# Groundwater Application Review Summary Form

Application # G- 18748

GW Reviewer Michael Thoma Date Review Completed: 06/15/2020

TO: Water Rights Section Date 06/15/2020  
 FROM: Groundwater Section Michael Thoma  
Reviewer's Name  
 SUBJECT: Application G- 18748 Supersedes review of \_\_\_\_\_  
Date of Review(s)

**Stream-Depletion Model Results**

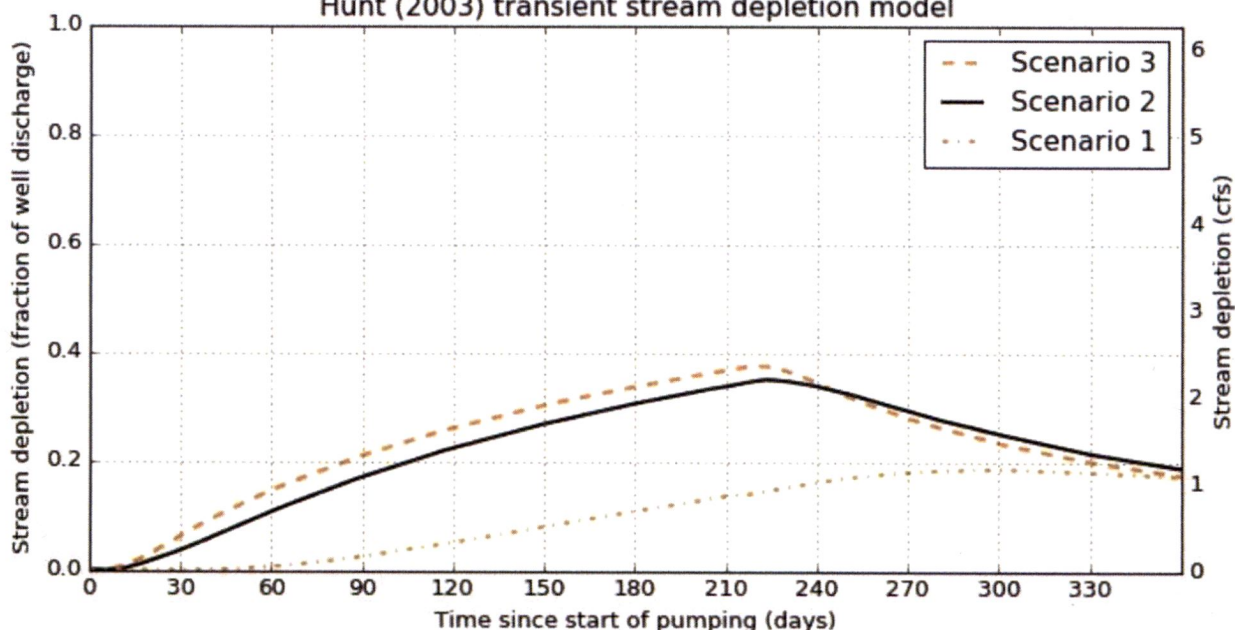
Stream-depletion was estimated using the Hunt (2003) stream-depletion model with parameter values informed by Gannett et al. (2012) and using methods previously used by the Department for estimating stream-depletion in the Klamath Basin.

Stream depletion for Scenario 2:

Days	10	300	330	360	30	60	90	120	150	180	210	240	270
Depletion (%)	0	25	22	19	4	11	17	22	27	31	34	34	29
Depletion (cfs)	0.01	1.58	1.35	1.18	0.23	0.67	1.07	1.41	1.69	1.92	2.12	2.13	1.84
